**RE: *Cemex Cement, Inc.***  
***Brooksville Cement Plant***  
***FDEP File No.: 0530010-026- AC - Indirect Firing Systems for***  
***Kiln No. 1 and Kiln No. 2***  
***Additional Information***

**Attachment 1**  
**Pillard Burner Modifications**

Attachment 2  
Conceptual FL Smidth Burner Proposal

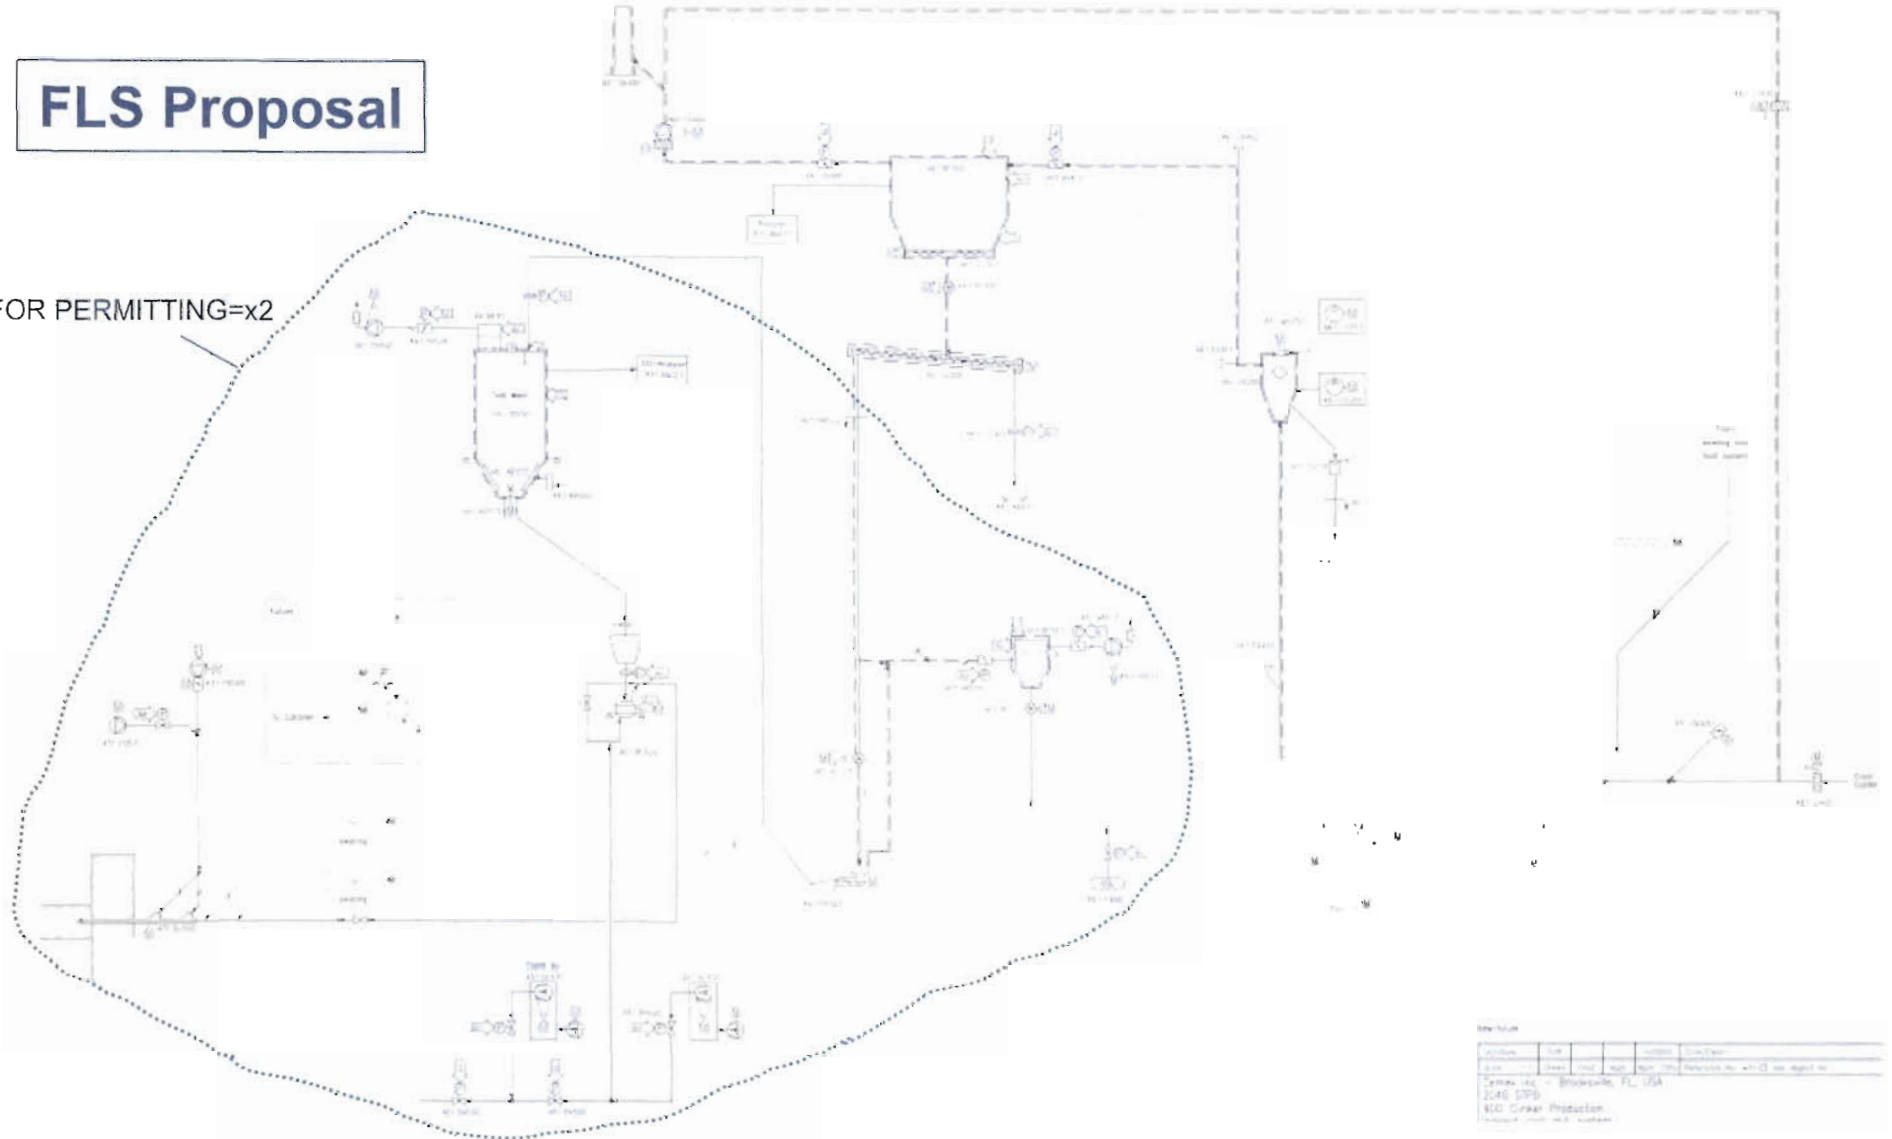
The potential modifications to the Pillard burners are shown in Attachment 1. These modifications may include, but are not necessarily limited to, new controls on the radial and axial air supplies, new solid fuel (coal and/or petroleum coke) feed to the burners, and new burner tips. None of these modifications will affect the principle of operation of the Pillard burners as described in the original application nor will the modifications adversely affect the performance of the burners or the potential air pollutant emissions from the two kiln systems.
